GOLDFINCH

4711-4717 Aurora Ave N, Seattle WA 98103 | Project# 3029853-LU

Northwest Design Review Board / Recommendation Meeting / 16 September 2019

partial plan // porch, entry, lobby, and lounge

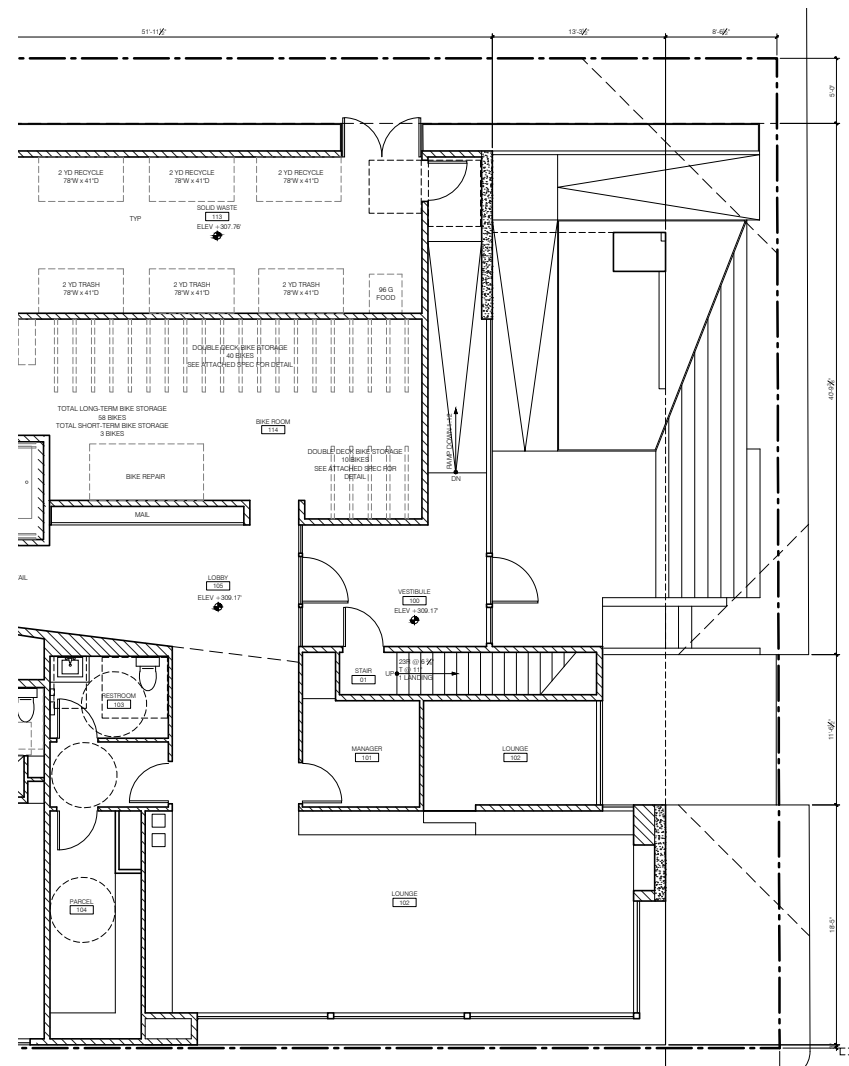
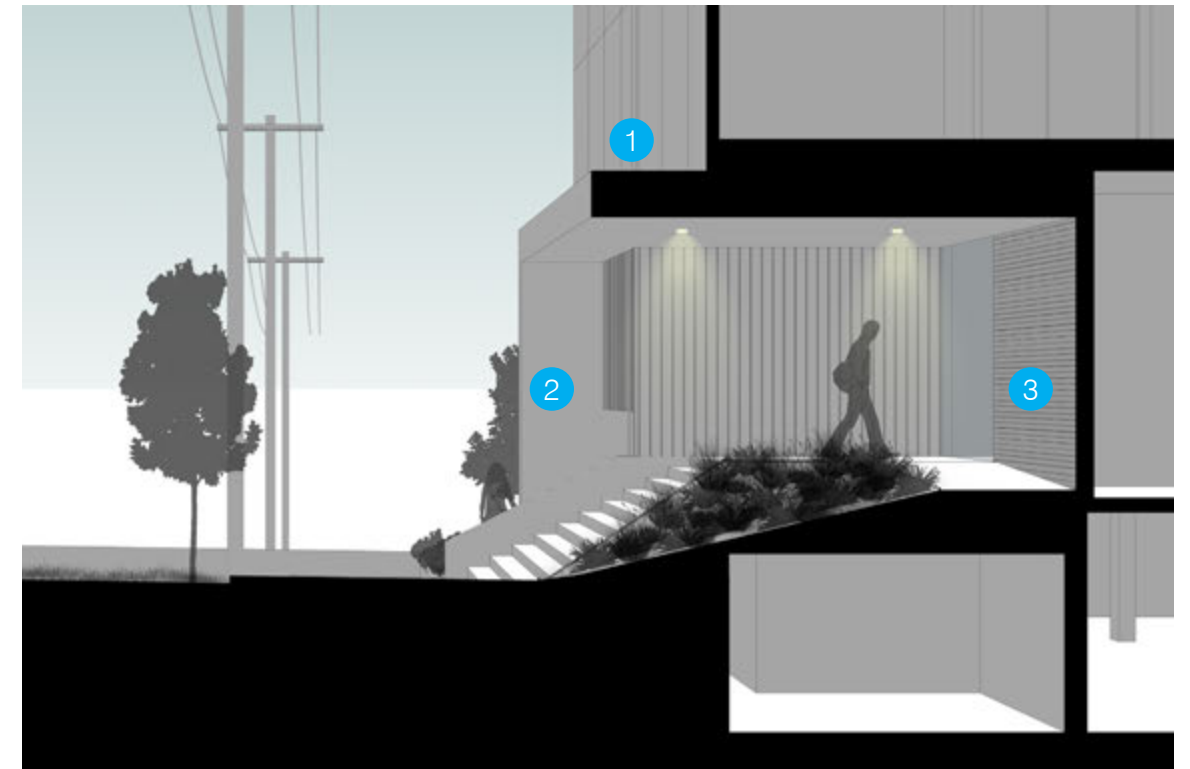
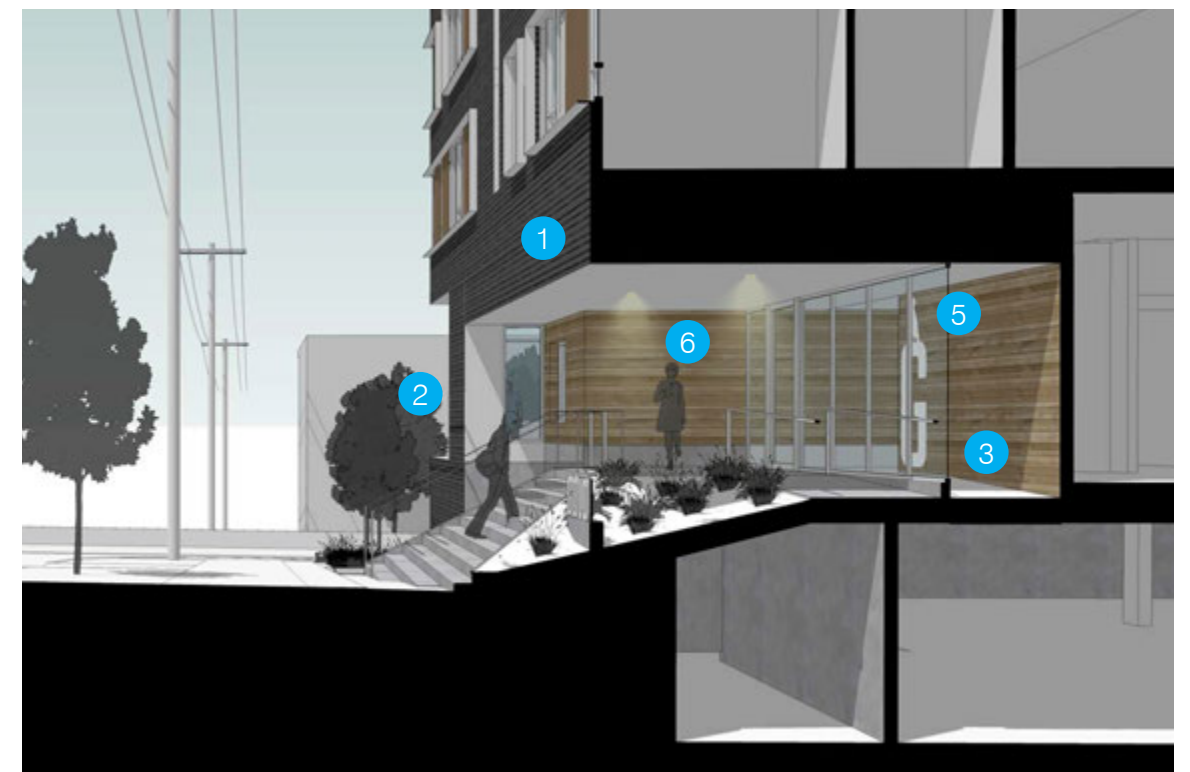
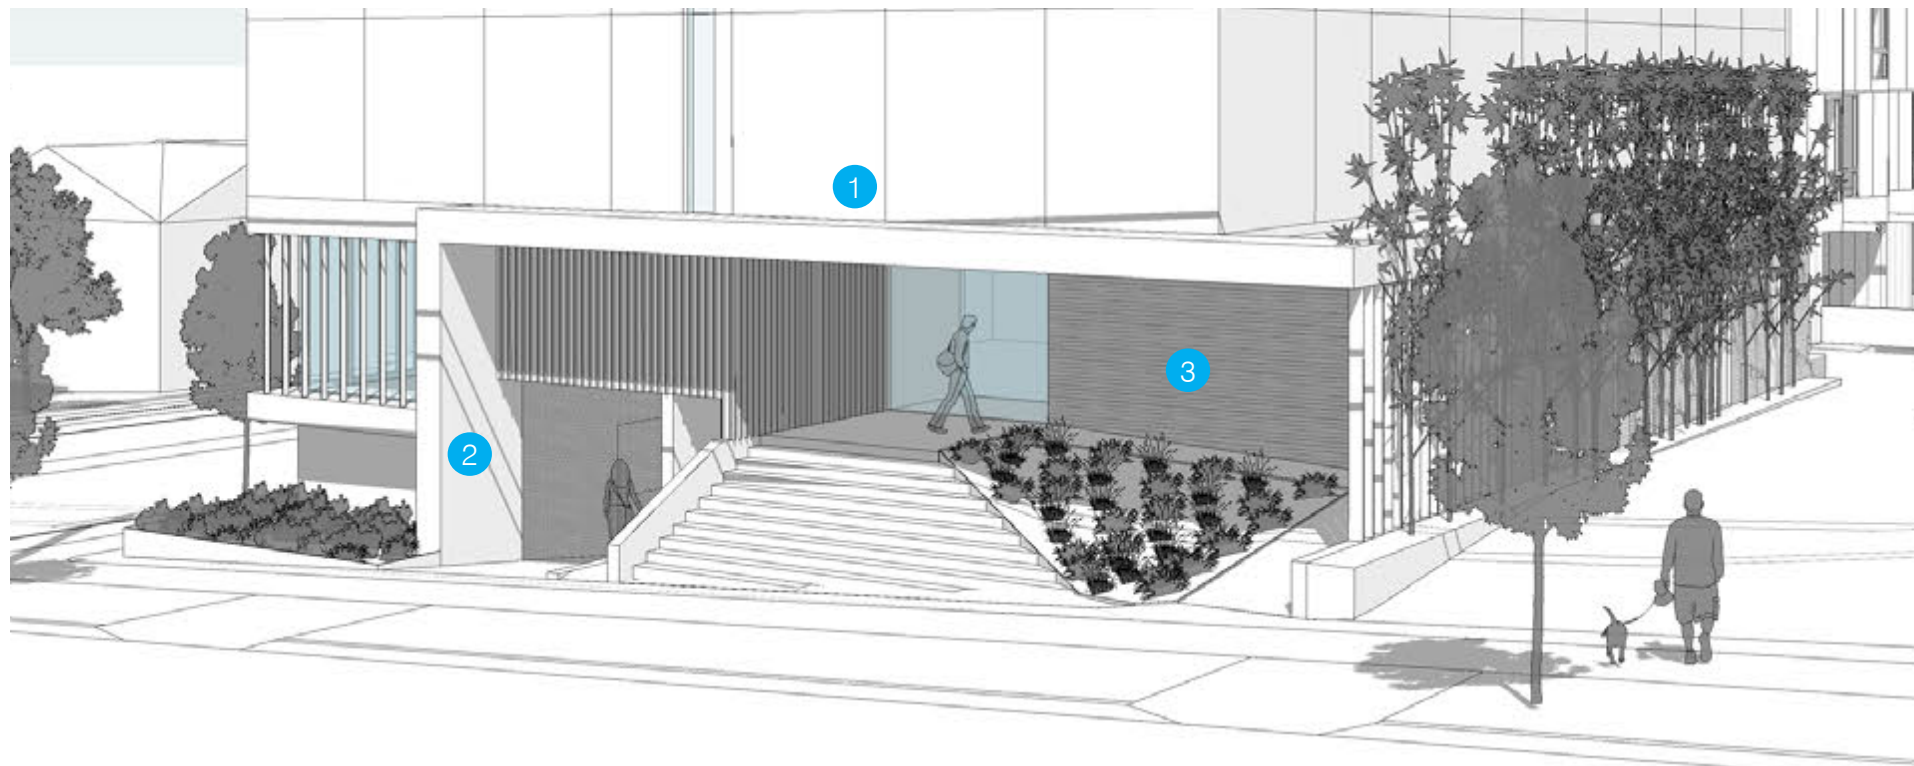
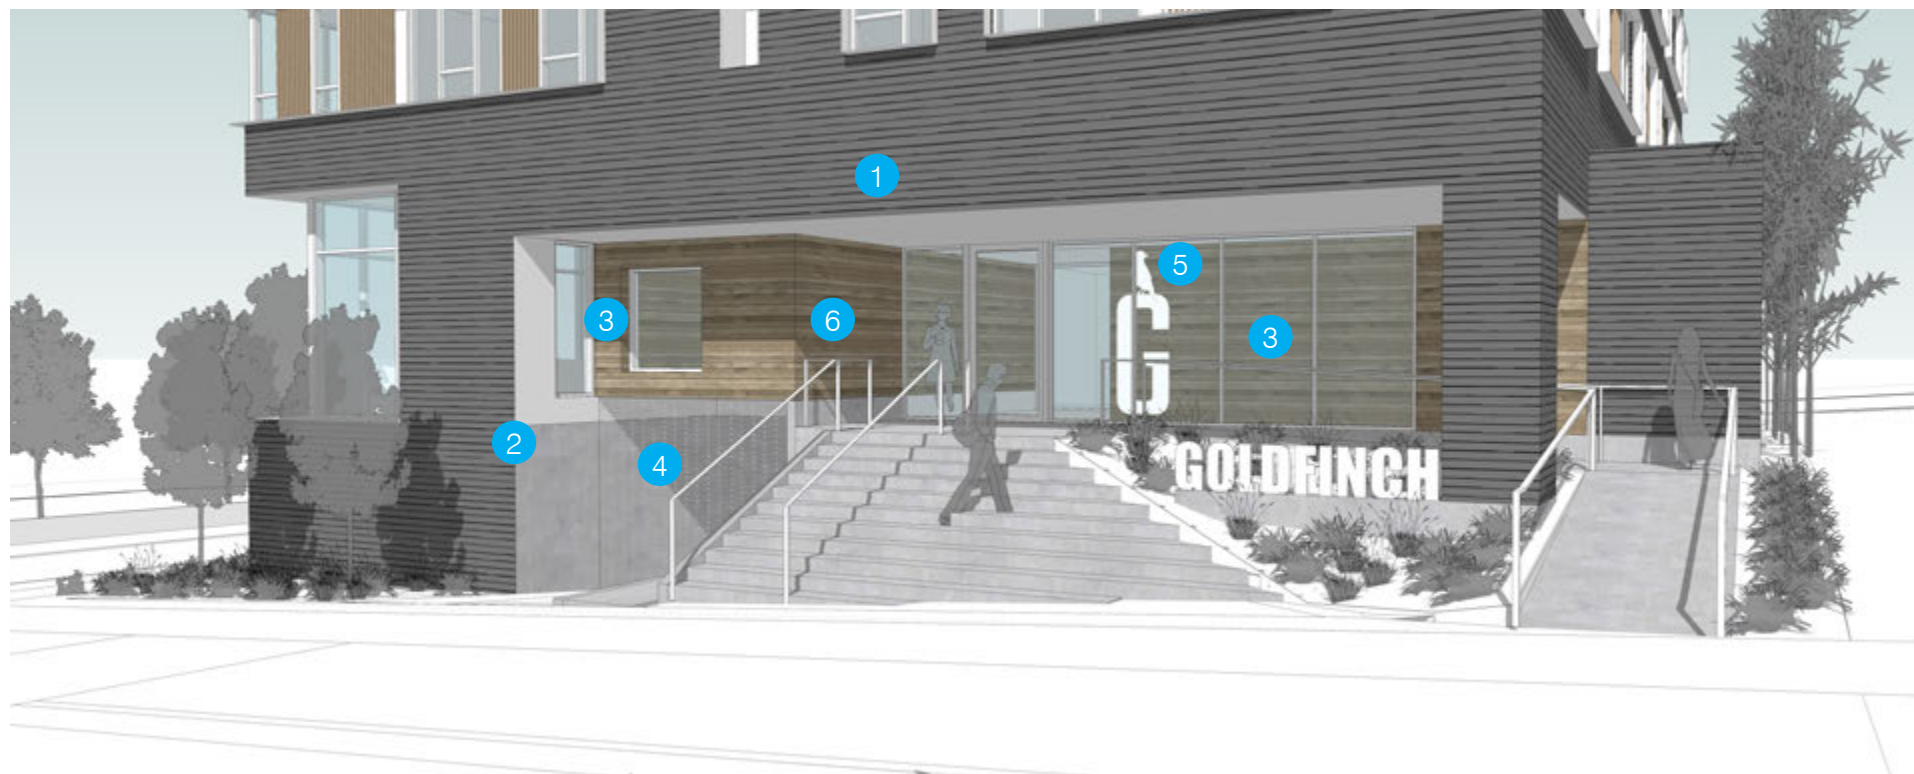
The Board observed that the opening along N 48th St described as the “entry porch” was very civic in scale and not in keeping with the surrounding residential scale and context of the site. While they agreed the entrance was well placed on N 48th St, they were concerned with the scale of the ‘porch’ and the lack of natural daylight at the north facing ‘porch.’ (PL3-A, DC1-A, DC1-C, DC2-A, DC2-B, DC2-D, DC3-C-2)

b. The Board gave guidance to redesign this area to respond to provide usable inviting outdoor space for residents and to respond to the nearby scale:

- i. Modify the framing element and the structures separating the ‘big porch’ from the garage entry to reduce the scale of the porch, reduce the appearance of the garage entry, and to further separate the pedestrian areas from the vehicular areas. (DC1-C, DC2-A, DC2-B, DC2-D, DC3-C-2)
- ii. Create openings in the building or use other strategies to allow light to filter into the porch area. (PL1-C)

The projecting canopy and the vertical wing walls have been eliminated to reduce the depth and allow more natural light into the porch.

The trash room has been turned to have the short edge fronting the porch to allow larger glazing area.

The interior exit stair has been flipped in order to provide a wider opening between the lobby and the porch.

The space above the garage entry has been changed into a small meeting room which further activates the porch and reduces the appearance of the garage entry.

Windows have been added across the south side of porch to expand the visual connection to the lobby. Windows have also been added in the lounge and small workspace to further increase the visual connections between the interior activity and the porch.

1. removed canopy
2. removed framing element. porch now reads as a carved-out slot instead of a framed element.
3. introduced more glazing
4. moved grilles garage door to be co-planar with the wall above. the garge entry reads as part of the wall instead of a void in the body.
5. wood cladded accent wall behind entry glazing, with painted logo.
6. stair core, manager office, and lounge are grouped into an “object” within the porch carve-out. same wood cladding is used on all sides to define the volume.
